TEXAS COMMISSION ON ENVIRONMENTAL QUALITY

NAME OF PROJECT: Guadalupe River Club Unit 3; Located on the north side of FM 306, east of the FM 2673 and FM 306 intersection; Comal County, Texas

TYPE OF PLAN: Request for Approval of a Contributing Zone Plan (CZP); 30 Texas Administrative Code (TAC) Chapter 213 Subchapter B Edwards Aquifer
 Edwards Aquifer Protection Program ID No. 2848.00; Investigation No. 722973; Regulated Entity No. RN105670590

**COMMENT RESPONSE TO
TEXAS COMMISSION ON ENVIRONMENTAL QUALITY (TCEQ)
COMMENTS FEBRUARY 23, 2009**

EROSION & SEDIMENTATION
CONTROL PLAN

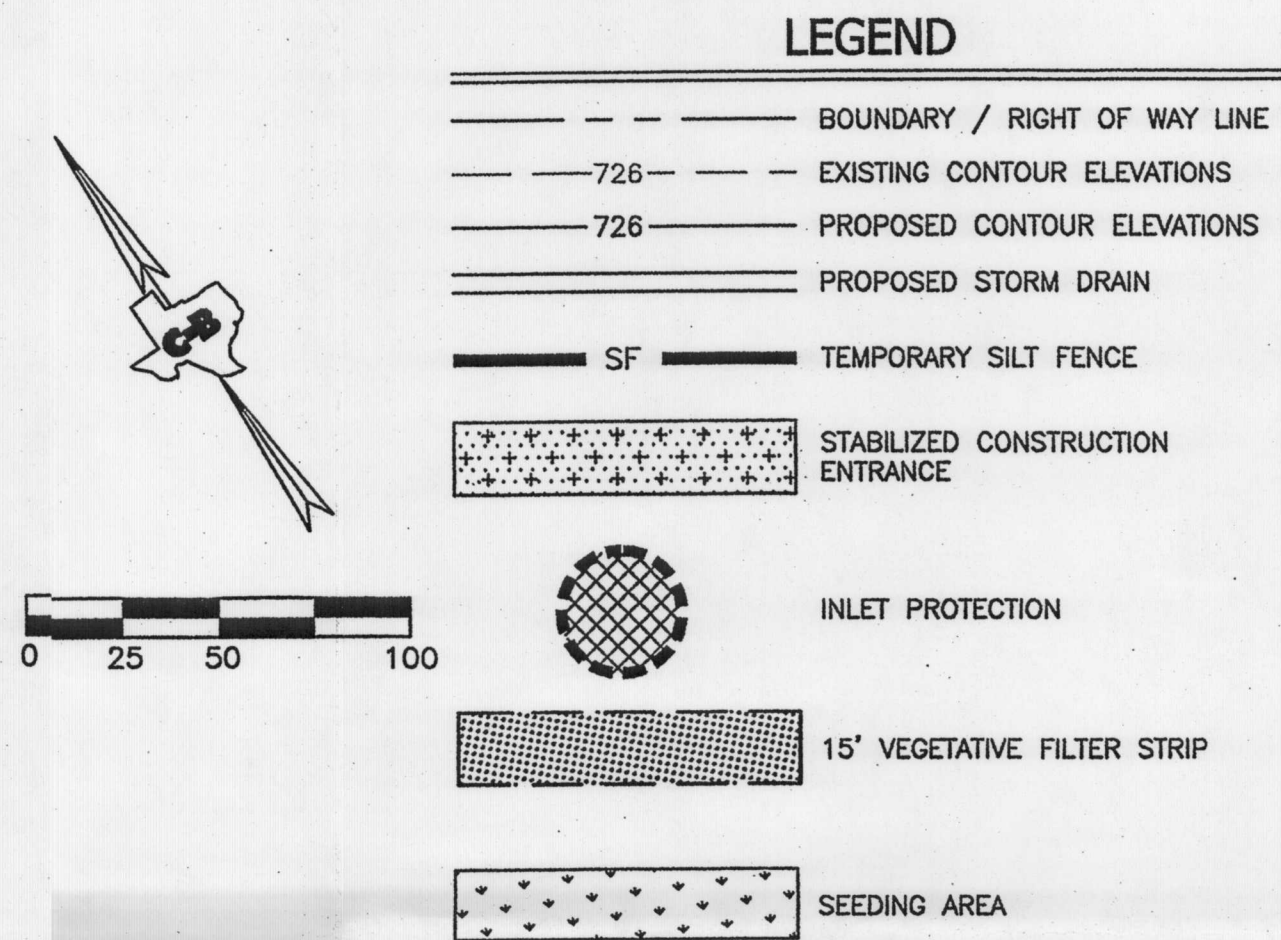
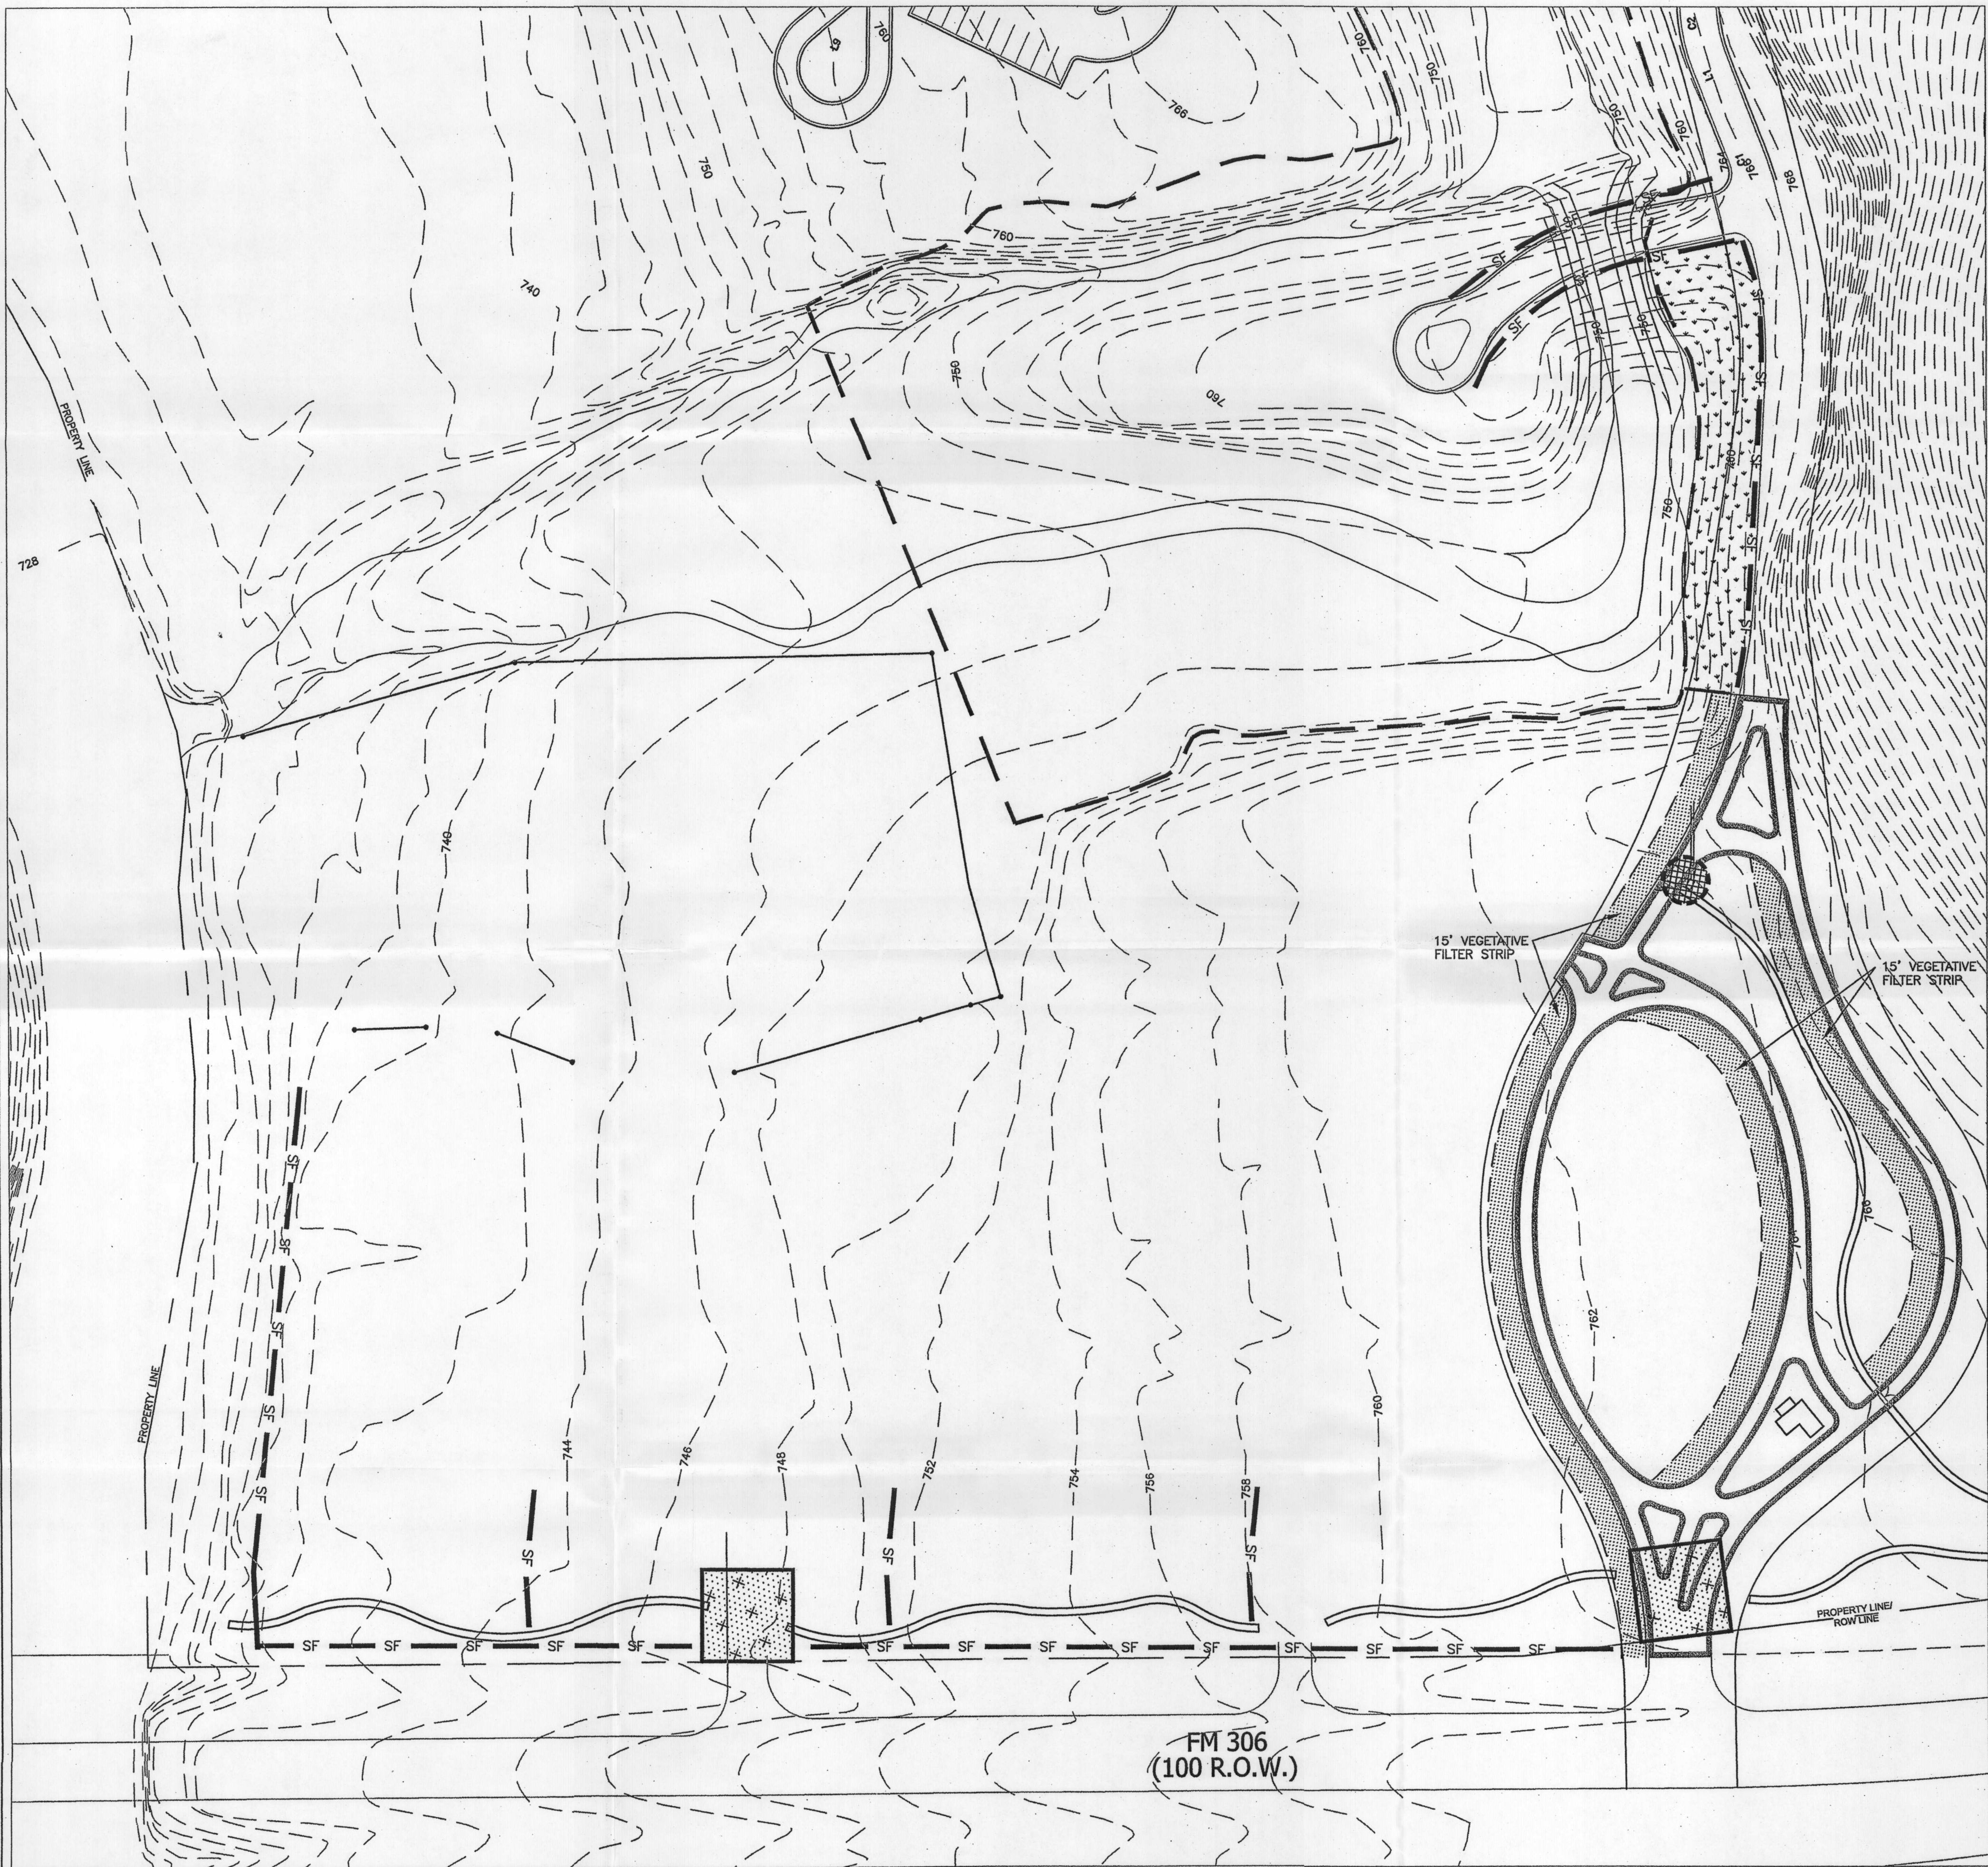
1. Update the site plan to show finished contours of the roadway.

2. It appears that stormwater runoff will be allowed to exit the site/project limits prior to receiving treatment by sediment/erosion controls during the construction phase (see attached exhibit). Verify that the temporary measures will retain sediment onsite to the maximum extent practicable, and update the plan sheet to exhibit additional controls as necessary.

We have complied; please see comment #3 for attached sheet reflecting contours

The concrete road in this area will no longer be constructed at this time; however, we have installed temporary erosion control measures to retain sediment onsite. These measures are shown on the attached plan as well as in the construction documents.
